Proposal for draft amendments to Regulation No. 86 (Installation of lighting and light-signalling devices for agricultural tractors)

**Submitted by the Chair of the Informal Working Group on
Agricultural Vehicles Lighting Installation***

The text reproduced below was prepared by the GRE Informal Group "Agricultural Vehicles Lighting Installation" (AVLI), to update and revise Regulation No. 86. It is based on the document E/ECE/324/Rev.1/Add.85/Rev.1. The modifications to the current text of the UN Regulation are marked in bold for new or strikethrough for deleted characters.

Model A
(See paragraph 4.4. of this Regulation)

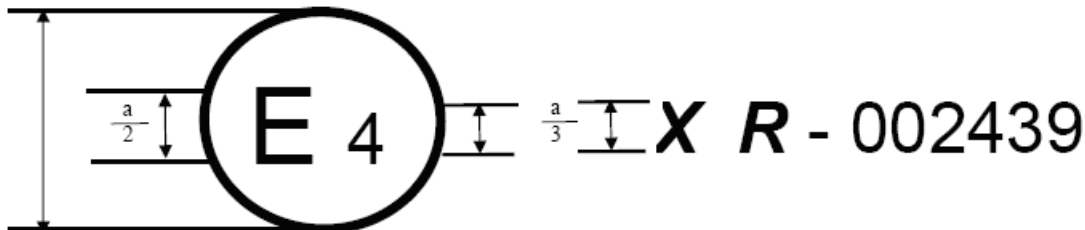
The above approval mark affixed to an agricultural or forestry ~~vehicle~~ **tractor** shows that the ~~vehicle~~ **tractor** type concerned has, with regard to the installation of lighting and light-signalling devices, been approved in the Netherlands (E 4) pursuant to Regulation No. 86. The approval number indicates that the approval was granted in accordance with the requirements of Regulation No. 86 in its original form.

Direction-indicator lamps - Geometric visibility

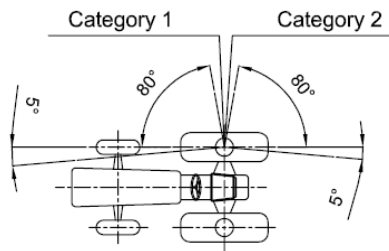
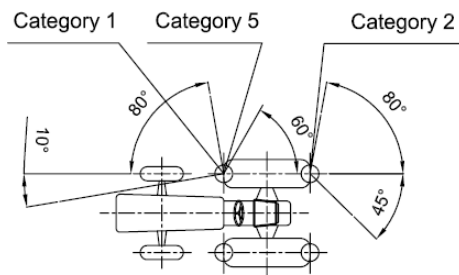
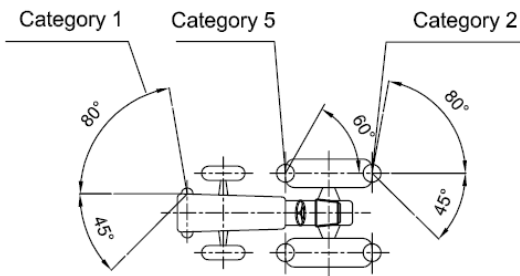
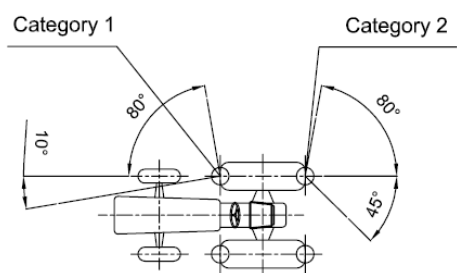
Annex 5 ((to be amended editorially according to 6.5.1, i.e add 1a or 1b after 1, replace 2 by 2a in the figures))
